Subject: **Folding Key Radio Remote Control, Functions Only at
Close Range**

Number: **05-03**

Model(s): **Touareg**

Date: **Oct. 21, 2005**

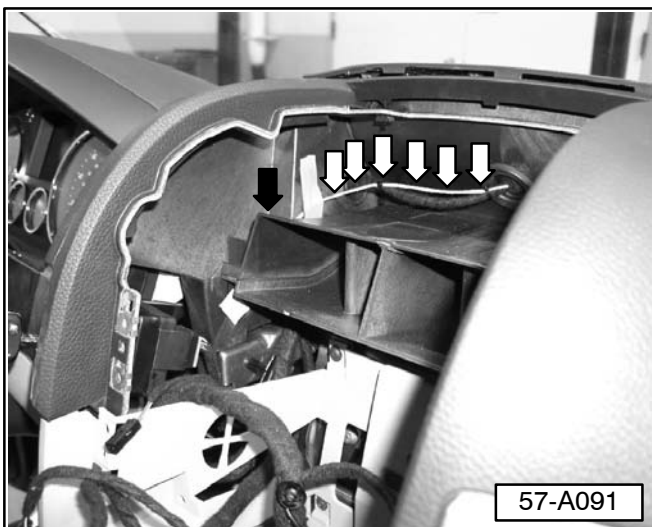
- Locate and remove terminal 62 for remote antenna wire -R168- (clear wire sheathing) (see appropriate VESIS wiring diagram if necessary).

- Terminate this wire using a cut, fold and tape method.

- ◀ – Route 1000 mm (3 ft.) .5 mm wire down alongside of center air distribution duct (black arrow) to Access/Start Control Module -J518- as shown.

- Splice 1000 mm (3 ft.) bulk .5 mm wire to new terminal wire Part No: 000 979 003 using butt splice - Part No: 111 971 941A (see VAS 1978 Wiring Harness Repair Manual for instructions).

- Insert terminal into cavity 62 of Access/Start Control Module -J518- connector.

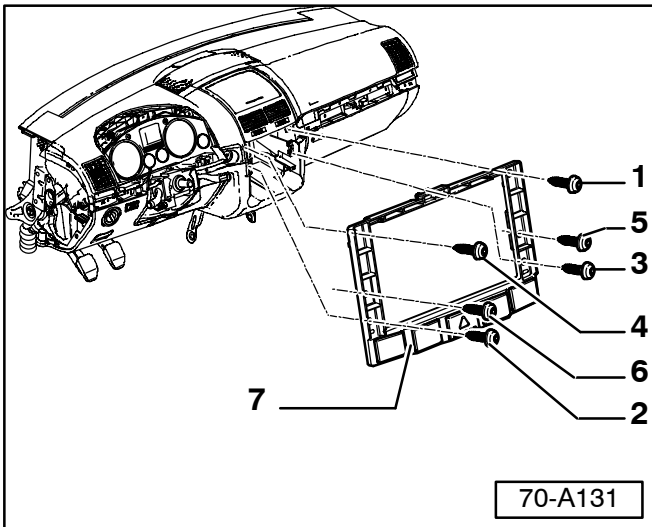
- Reinstall hard-shell housing on Access/Start Control Module -J518- connector.
- Secure wire leading to (Access/Start Control Module -J518-) as necessary (to eliminate any rattles).
- Reinstall Access/Start Control Module -J518-.
- Finish new antenna wire routing along existing harness (white arrows shown in 57-A091) to grommet.
- Secure wire into position with tie straps and tape.
- Trim excess wire so that wire terminates at grommet.
